Agenda
Village of Arlington Heights
Design Commission
Community Room, 3rd Floor

Arlington Heights Village Hall
33 S. Arlington Heights Road
Arlington Heights, IL 60005
January 9, 2018
6:30 PM

- A. DC#17-156 - Sigwalt Apartments - 45 S. Chestnut Ave. - Multi-Family

MINUTES OF
THE VILLAGE OF ARLINGTON HEIGHTS
DESIGN COMMISSION MEETING
HELD AT THE ARLINGTON HEIGHTS MUNICIPAL BUILDING
33 S. ARLINGTON HEIGHTS RD.
DECEMBER 12, 2017

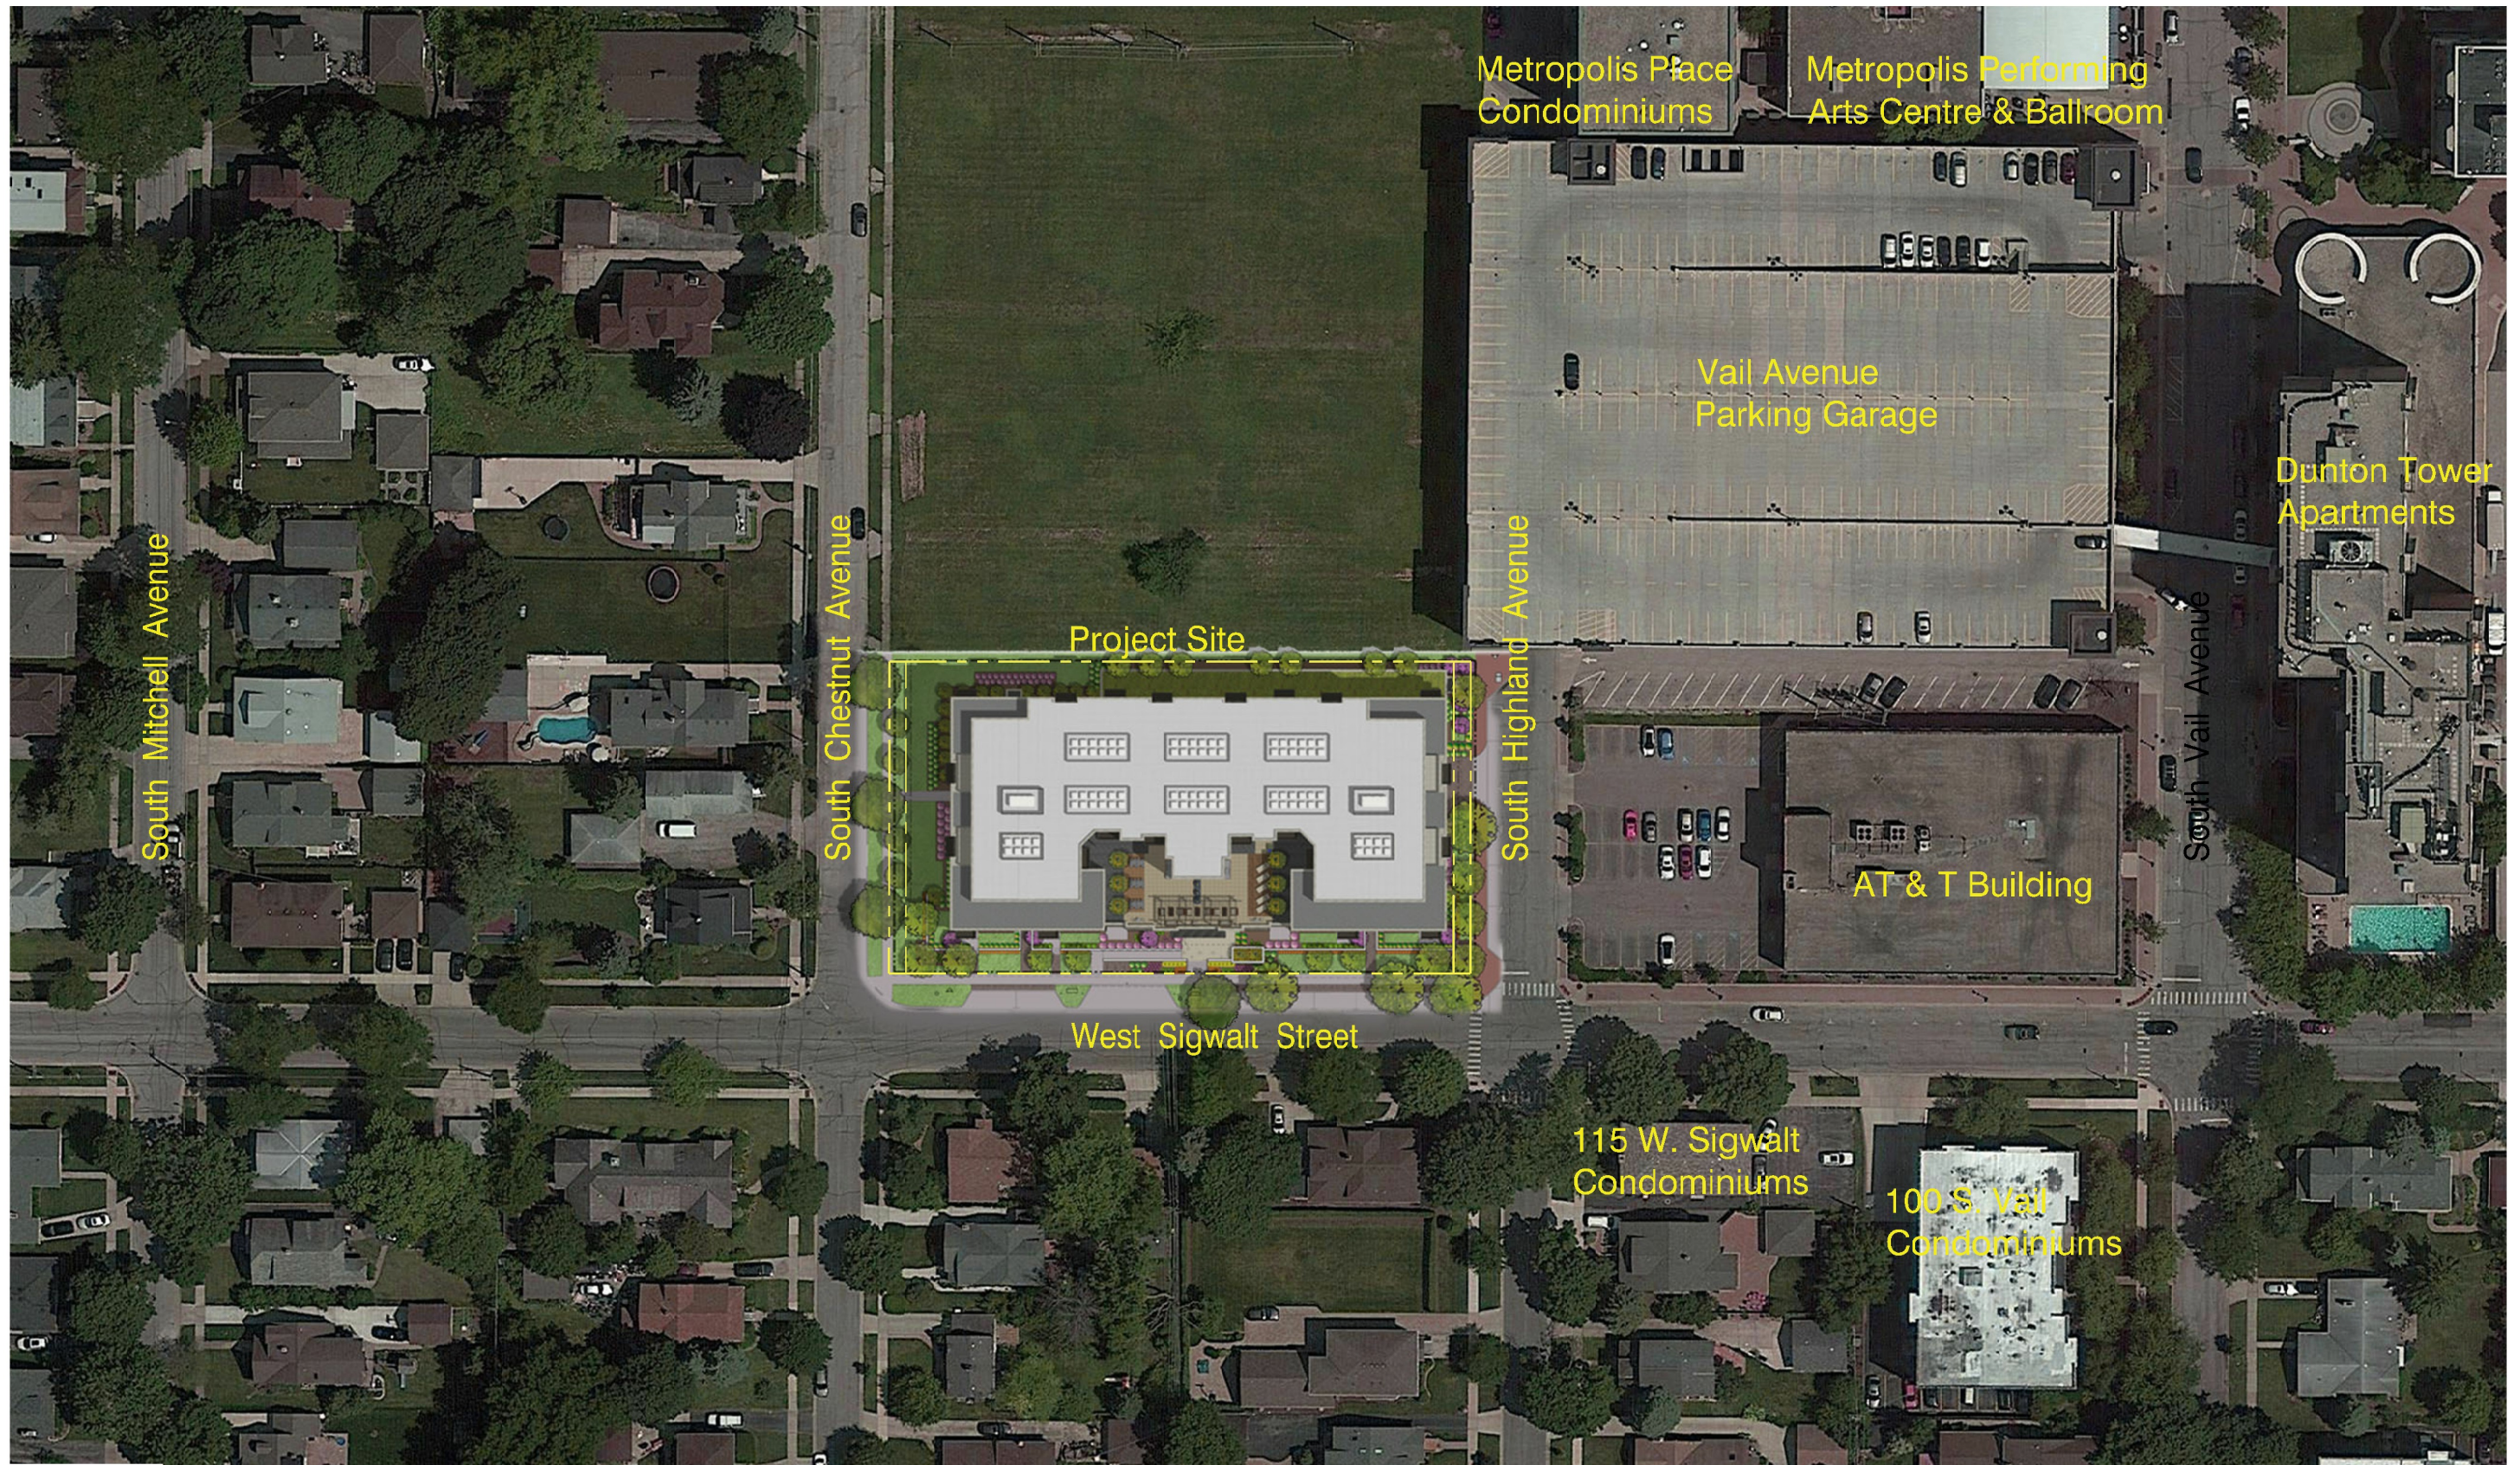
The only suggestion to improve the design is to add more windows on the top floor to break up the amount of wall siding and lighten the appearance.

1. It is recommended that additional windows be added to the top floor to break up the amount of wall siding.
2. This review deals with architectural design only and should not be construed to be an approval of, or to have any other impact on nor represent any tacit approval or support for the proposed land use or any other zoning and/or land use issues or decisions that stem from zoning, building, signage or any other reviews. In addition to the normal technical review, permit drawings will be reviewed for consistency with the Design Commission and any other Commission or Board approval conditions. It is the architect/homeowner/builder's responsibility to comply with the Design Commission

West Elevation

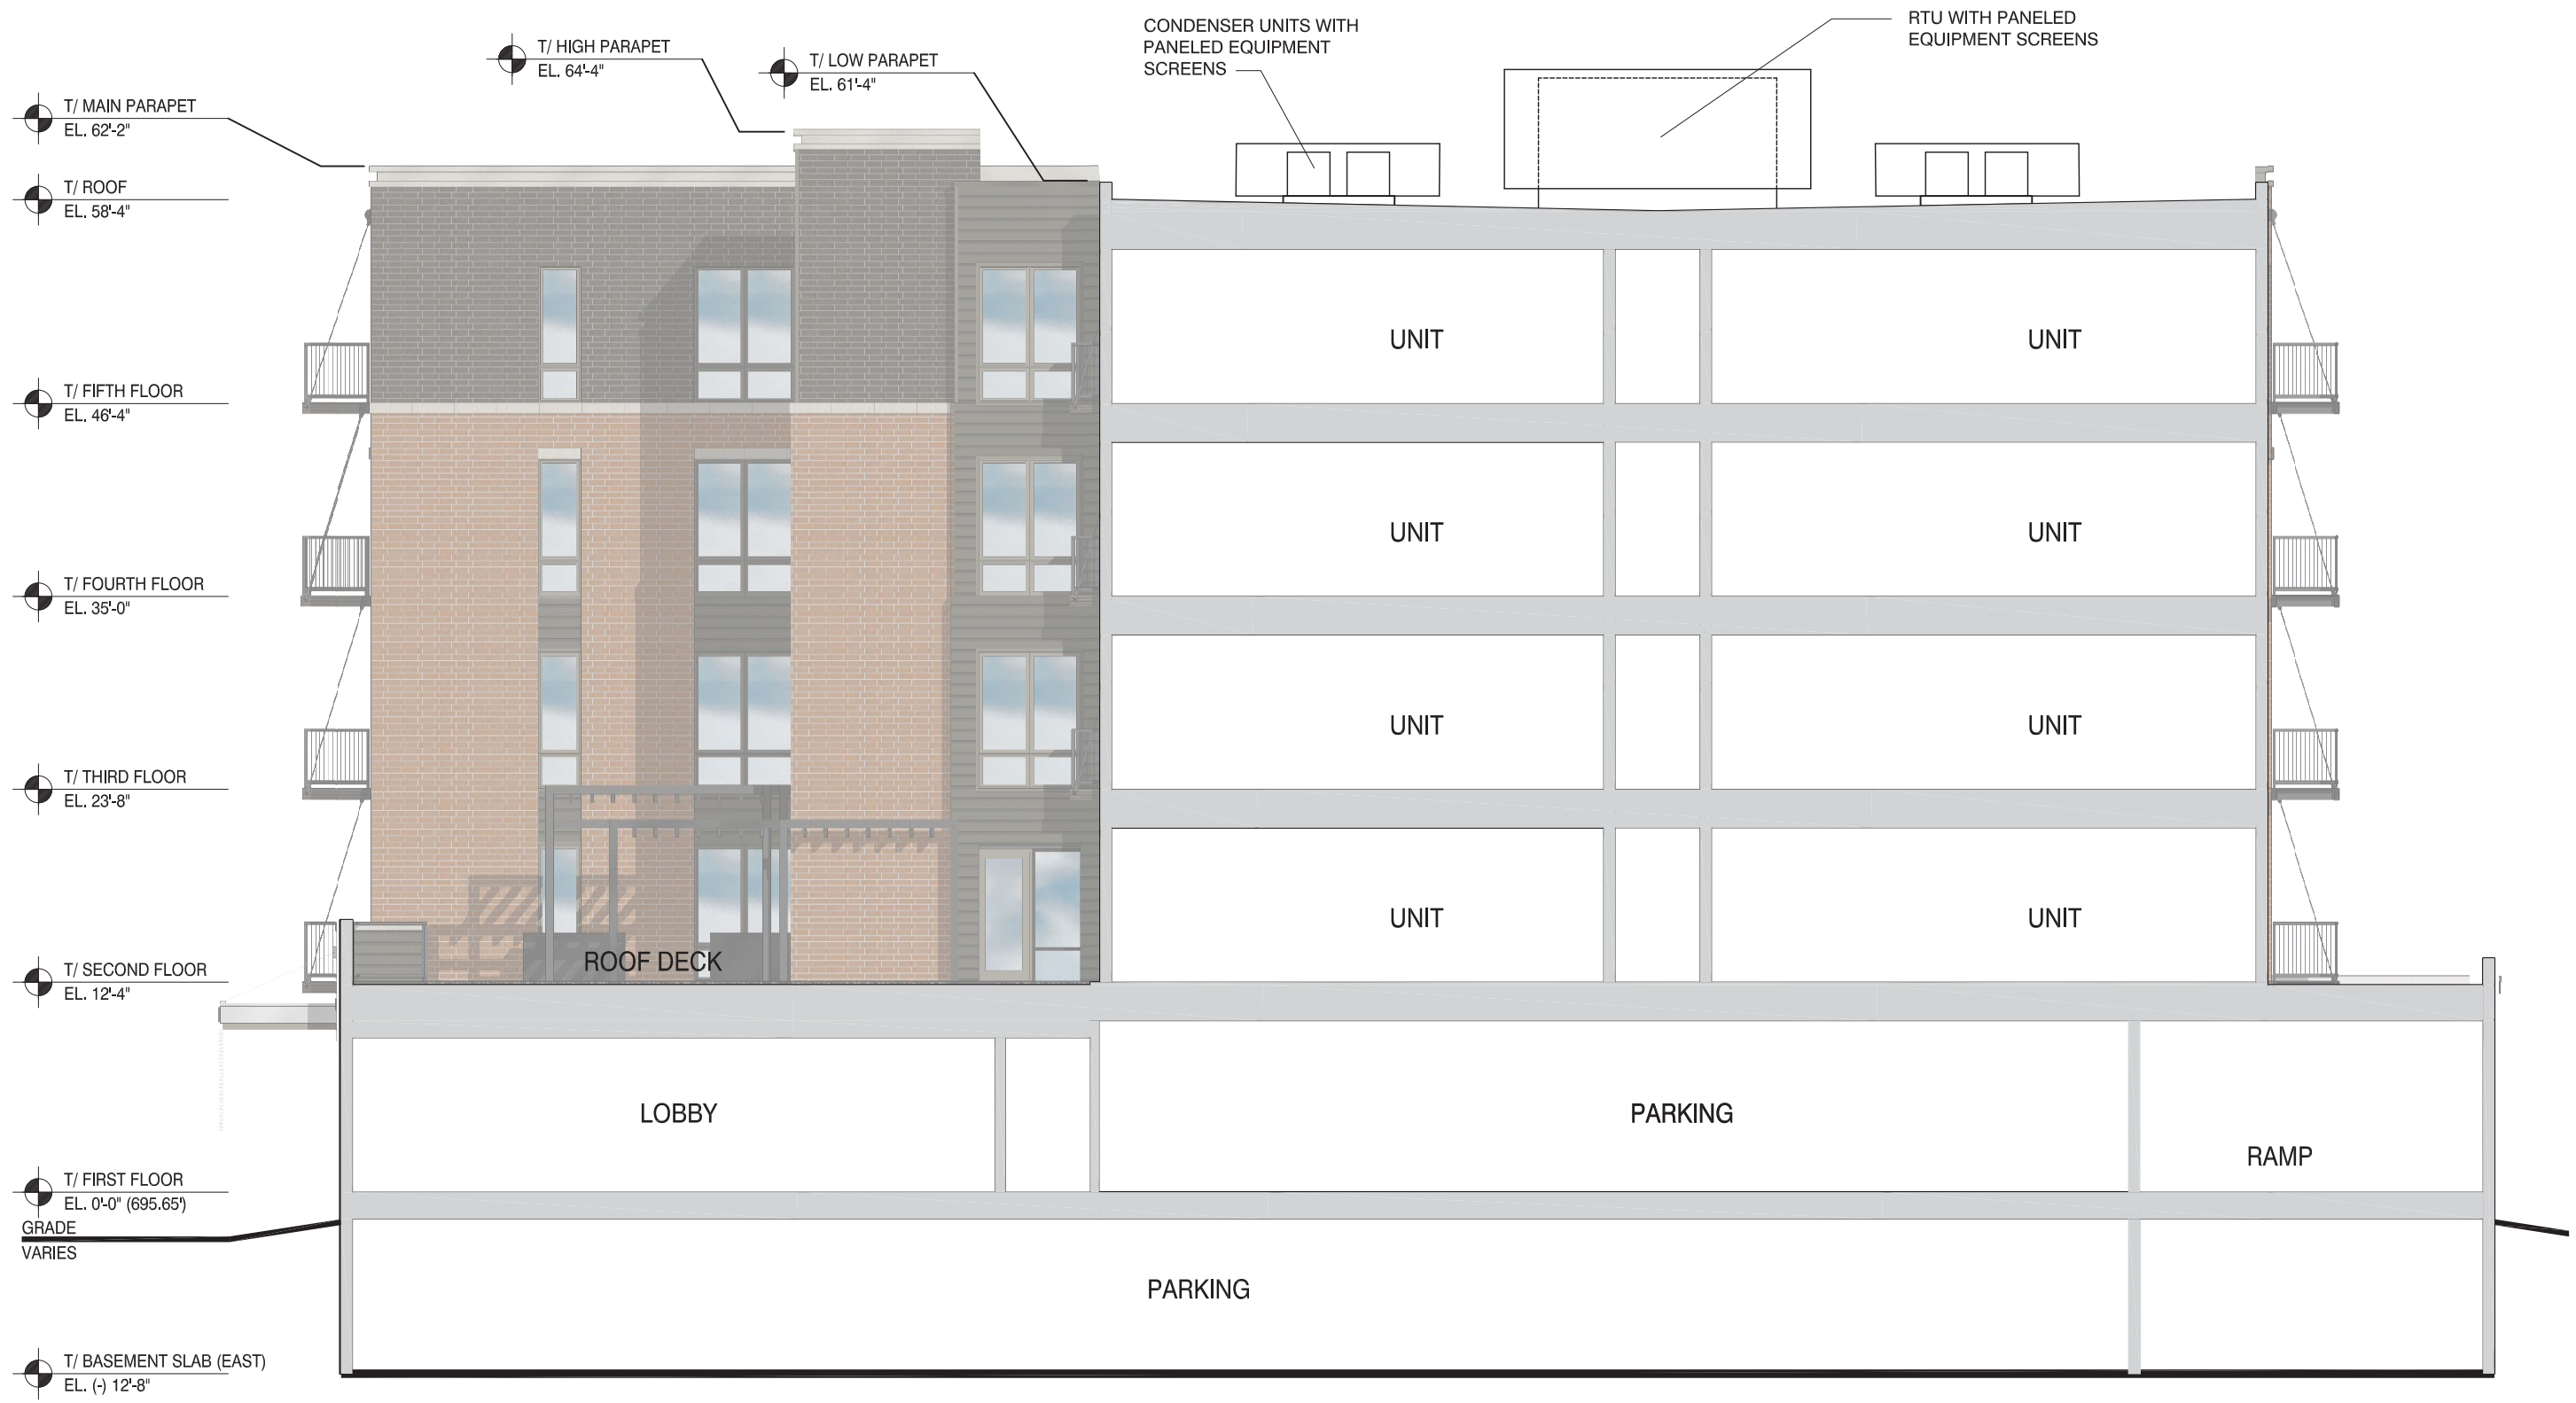
6. Landscaping. Additional landscaping has been added to the west elevation to soften the building wall. Additional landscaping has also been provided around the electrical transformer, and specialty paving has been added to the main entry landing.

- Overall, the landscape design is nicely done, and the additional landscaping along the west wall is a nice improvement which will help to soften the building wall and provide an enhanced buffer for the houses directly across the street. The specialty paving at the main entrance is a nice enhancement to the design and arrival experience.
